# Errors and Inadequacies

## SSD-82899468, 1-5 Nelson Rd Lindfield

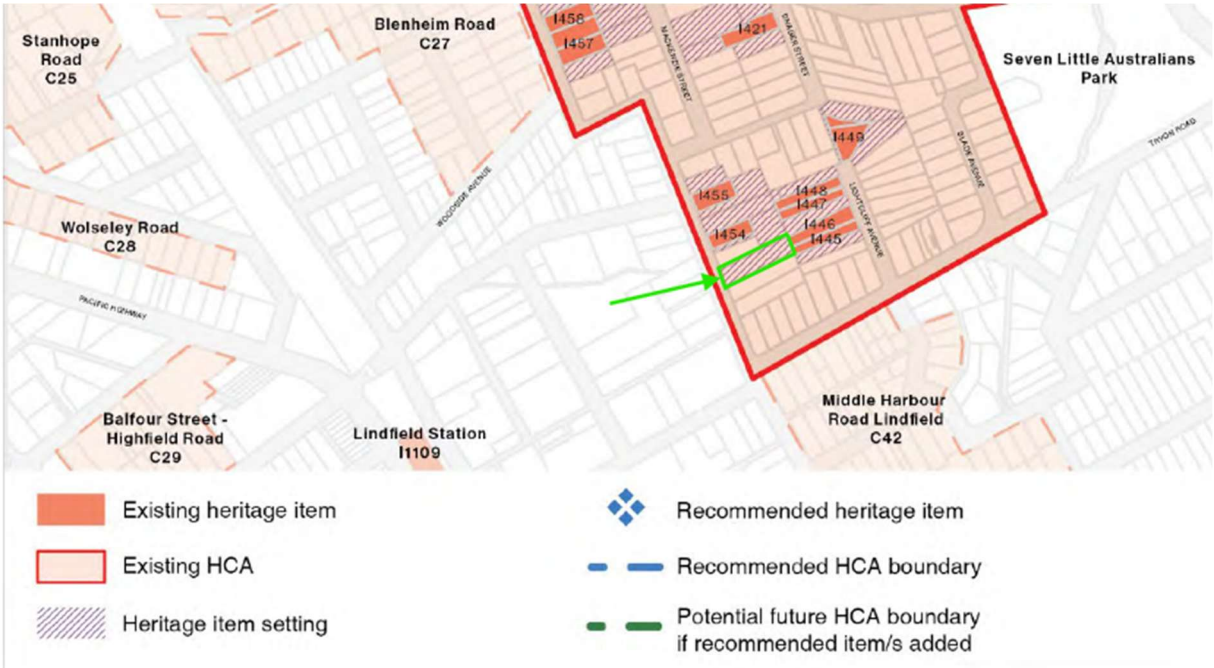
9.19	Insufficient setback	Parts of the south-eastern building have a setback of less than 6m – see DA304
	9.20	Incorrect AH GFA	The Affordable GFA schedule in the bottom right corner of DA502 shows Level 05 having 431m <sup>2</sup> . However, no Affordable Housing apartments were shown on Level 05 on DA502. Furthermore, hallways were included (shaded) as part of AH GFA on DA502 which may have led to an over-estimation of AH GFA. These have implications on satisfying the requirement for the 30% increase in uplift.

EIS Appendix 21  
– Integrated  
Water  
Management  
Plan

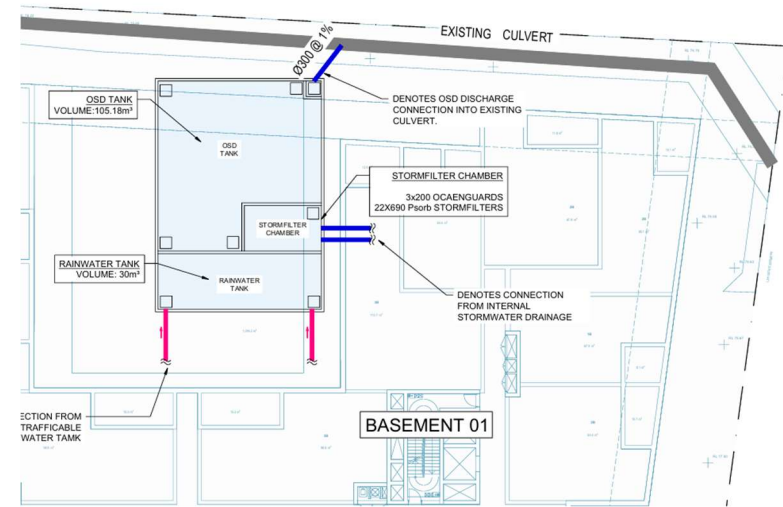
21.1 Onsite detention tank intends to ensure discharge is minimised, but there is also another discharge which is not controlled

A second easement (/discharge) is detailed in architectural drawing DA102 near the northeast corner of the proposed site – see screenshot below - but does not appear to be from the detention pit. Details of what is collected and discharged from this second discharge site has not been detailed and could lead to uncontrolled downstream flooding.

Drawing S01-SW302 from SGC (screenshot below) acknowledges the easement but does not include details of what it will be used for. A photo of this second existing 300mm diameter outlet is also shown below.
